June 10, 2021 Planning Commission Meeting

450 Colwell Ln (Condos) Conditional Use Application Packet (page 2)

**RE: 450 Colwell Lane - Application for Conditional Use
Dryden Court Development, LLC - Multi-family Development Stacked Condos
Our Reference No. 16140.009**

Re: Revised Determination - 450 Colwell Lane – Stacked Condominiums Conditional Use

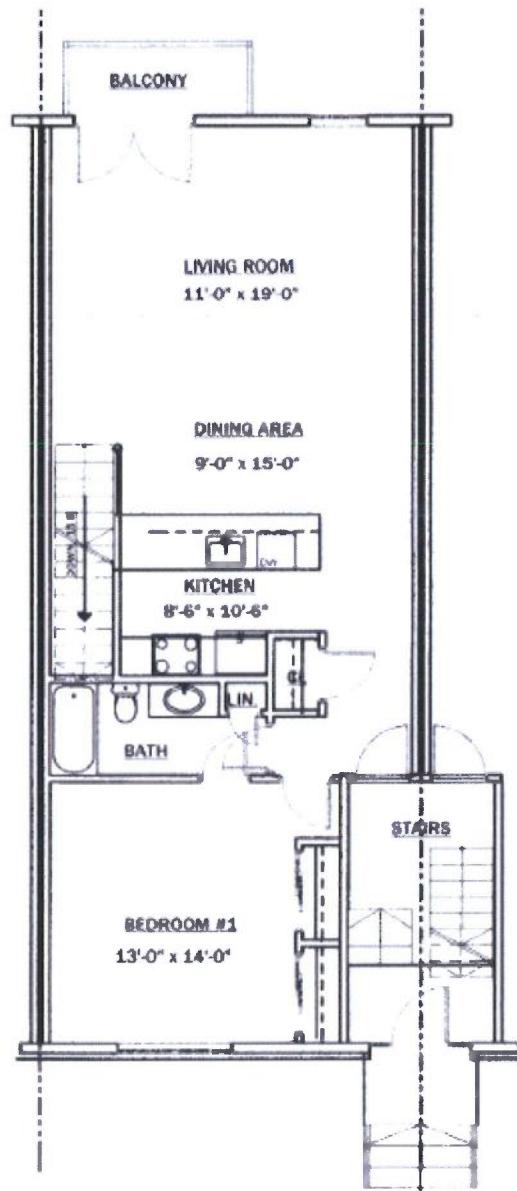
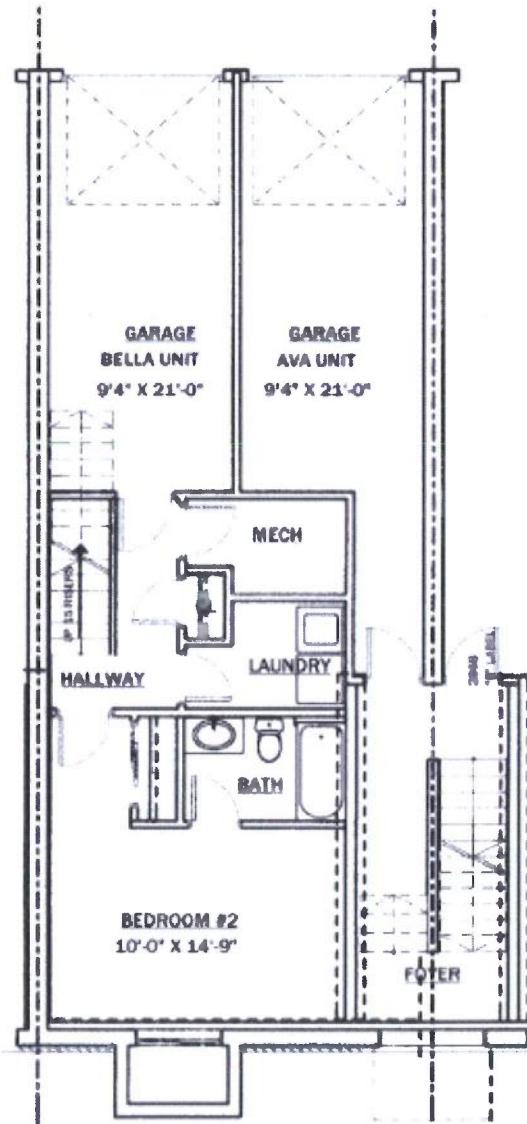
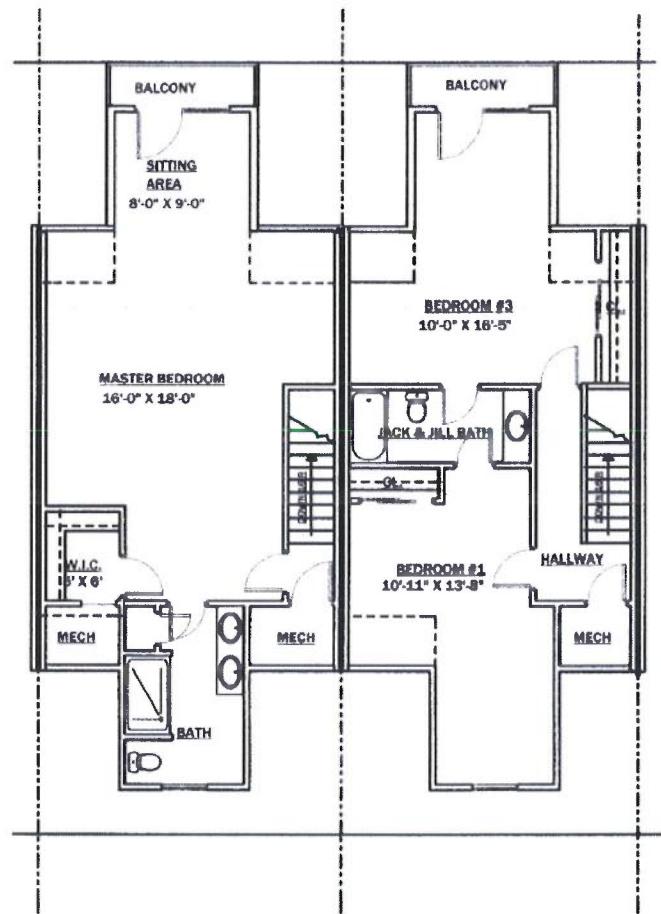
Per §27-830, decks are only permitted to be constructed at ground level or first floor of a dwelling. The provided building floor plans indicate decks on the upper levels of the dwellings.

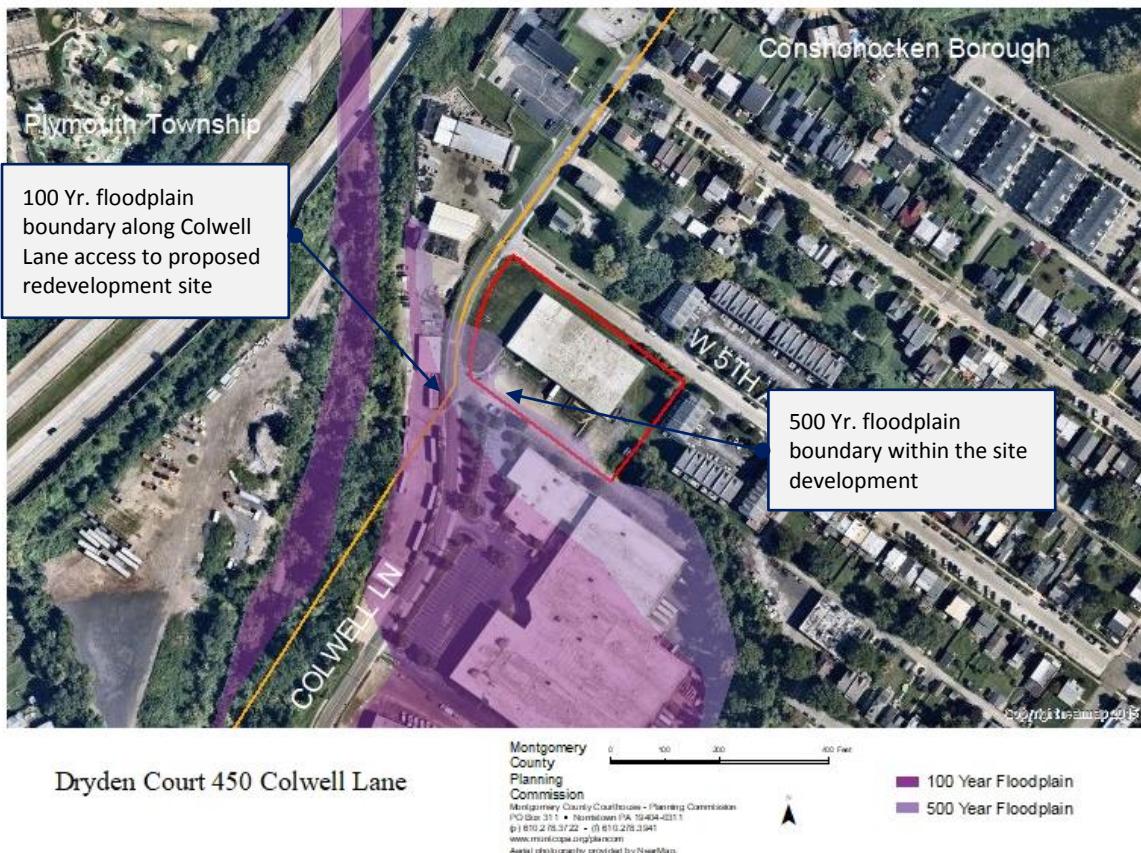
Given the significant challenges posed by potentially damaging flooding that could endanger the public's safety and welfare, we do not believe that residential redevelopment at this site is an appropriate land use. As shown in the accompanying aerial, the site development's Colwell Lane access is adjacent to the 100 year floodplain boundary, and the 500 year floodplain lies within the southern boundary of the shared access driveway and surface parking lot. We suggest the Schuylkill River and Plymouth Creek floodplain and watershed are dynamic natural environments; often flooding events correspond to mapped boundaries, as shown below. Given the documented flood hazard areas and the ever increasing flooding posed by climate change, future flooding may be even greater. The borough will need to consider the impacts of not only past flooding events but future risks of ever-increasing flood events, and the potential impacts on the residential redevelopment of the site. Given these concerns, we believe that the opportunities afforded by the Limited Industrial land uses are more appropriate than a 24/7 human-occupied residential land use.
